## SERVICE BULLETIN No BO-20/2013 MDM-1 FOX

DESIGNATION-TYPE/MODEL: MDM-1 FOX

CONCERNS: verification of bonded joint between wing upper skin and spar  
by "tap-test"

Sketch No 1 Tap-test hammer

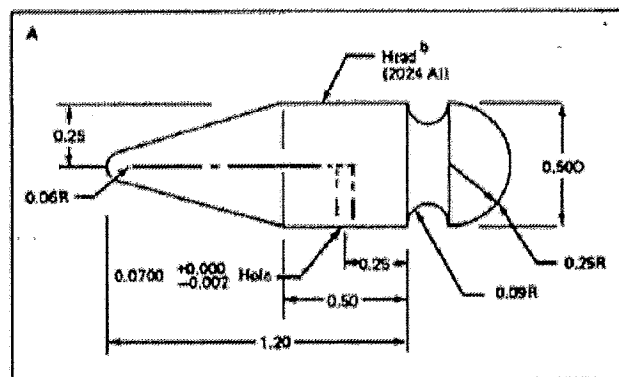
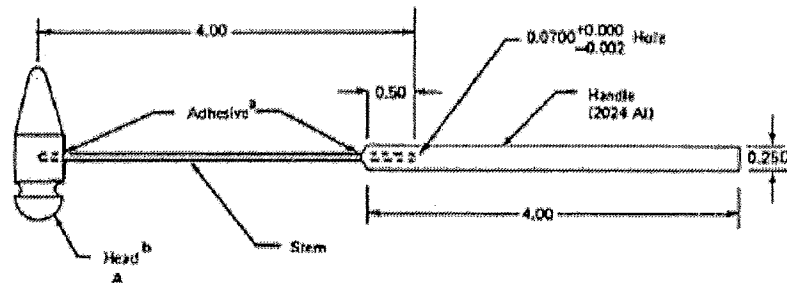
1. Disassemble the wings from the glider and support the verified wing panel horizontally on stable, vibration suppressing foundation – upper surface on top.
2. The verification is to be accomplished in a quiet area/ room
3. It is recommended to make the tap test with a "hammer" (sketch No 1 below) – however a bolt or coin (weight below 50 g) can give satisfying results.

Sketch No 2 Inspected area on upper surface of LH/ RH wing

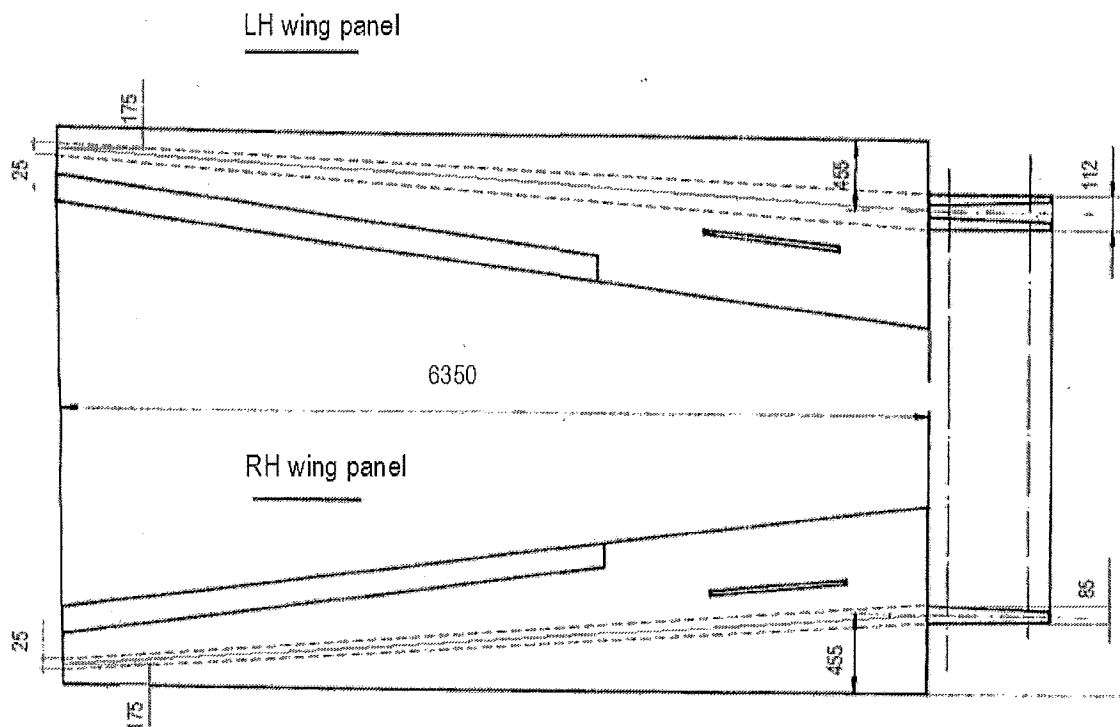
4. Prior to test, on wing upper surface contour with dashed line the area of bonded joint to be verified, as in the sketch No 2 below. Note there are different chordwise dimensions on LH and RH wing panels

Sketch No 3 Suggested path for tapping the bonded joint

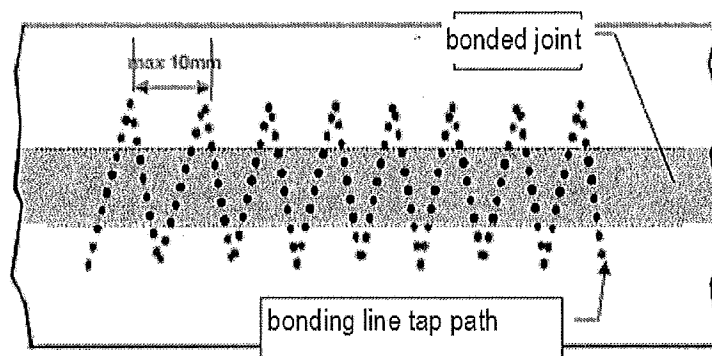
8. The bonded joint is to be tap-tested over the whole width and span, with subsequent strokes spaced evenly (see sketch No 3).
